Subject: **REQUEST FOR THE LIFTING OF "ON HOLD STATUS"** for the Section 401 Water Quality Certification for the proposed replacement of Bridge No. 118 over Lanes Creek on SR 1937 (Old Pageland Marshville Road) in Union County, Federal Aid Project No. BRZ-1937(2); Division 10; TIP No. B-4652; WBS 33818.1.1.

Reference: NCDOT Permit Application for a 404 Permit and 401 Water Quality Certification dated April 13, 2012.
NCDWQ on hold letter notification dated May 30, 2012.

Figure 1

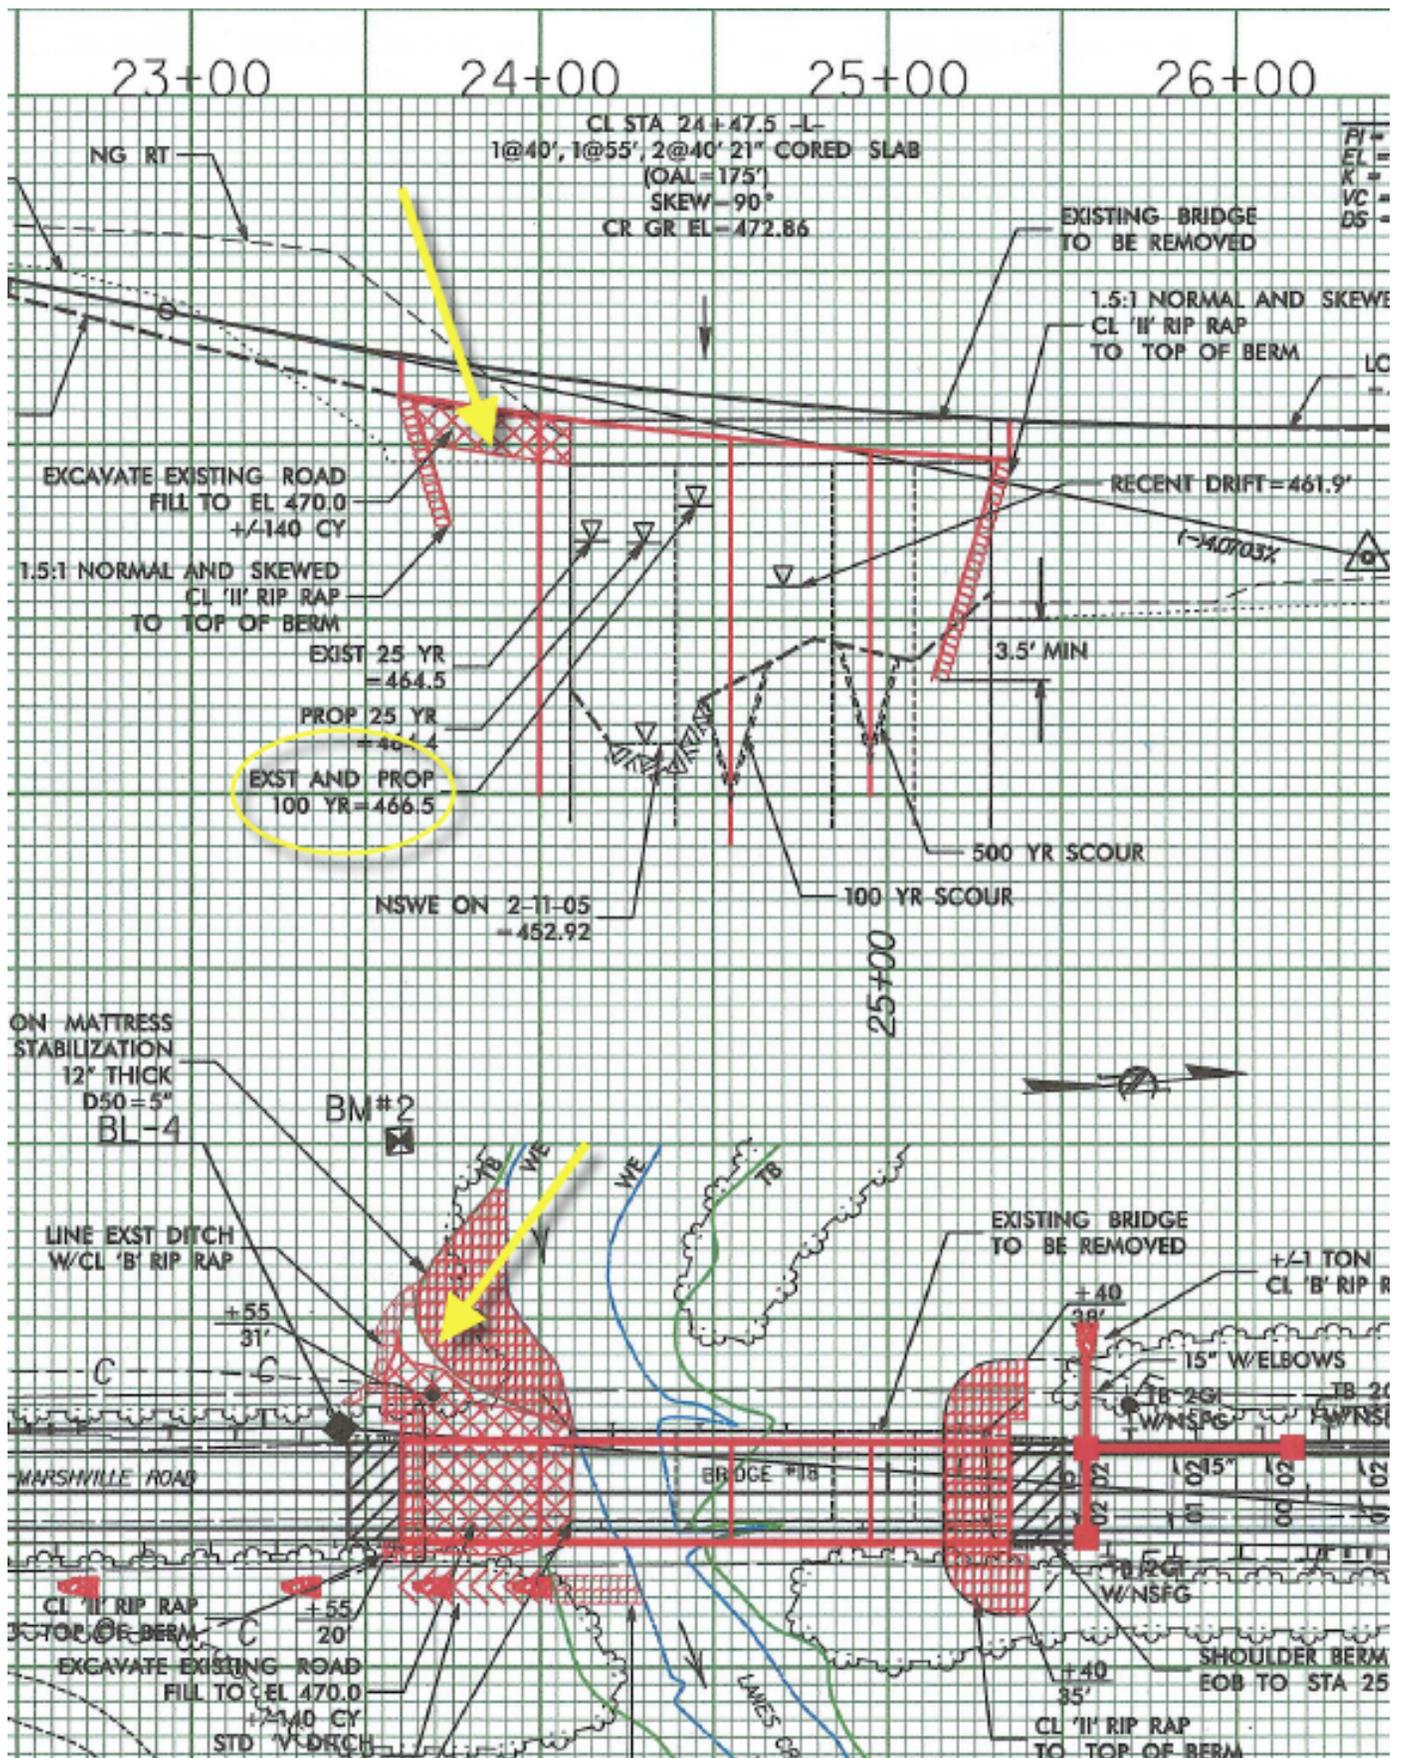
"A site visit indicates that the streambank for the proposed slope reinforcement appears to be fairly stable (including trees). It is unclear why this activity is necessary as the new bridge will be longer and provide additional floodplain availability for the stream. Additional floodplain availability will allow for energy dissipation on the floodplain rather than the streambanks. Provide information to support the request for the proposed 74 linear feet of stream impact. Additionally, if the need for the impact can be supported, DWQ does not typically authorize stabilization using gabions and would prefer a more natural method of streambank stabilization. Please provide an alternative form of stream bank stabilization."

Though the current bank identified above is currently stable, it is evident that channel flow has, over time, impacted the upstream, right bank causing the channel to migrate behind the

existing bridge's end bent. This is shown in the enclosed Figure 1, which is the plan view from the Bridge Survey Report.

In the bridge profile view, also depicted in Figure 1, shows that despite having a longer proposed structure, it does not provide any additional significant flow area in the floodplain than the existing bridge. The excavation (hatching) shown on the left (right upstream bank-yellow arrow) has been done to provide minimal area for future structure inspections and not increased floodplain flow. The design year and 100 year flood events do not even reach this excavated area. The attached plan sheet with contours (Figure 3) may help display a clearer picture of the situation.
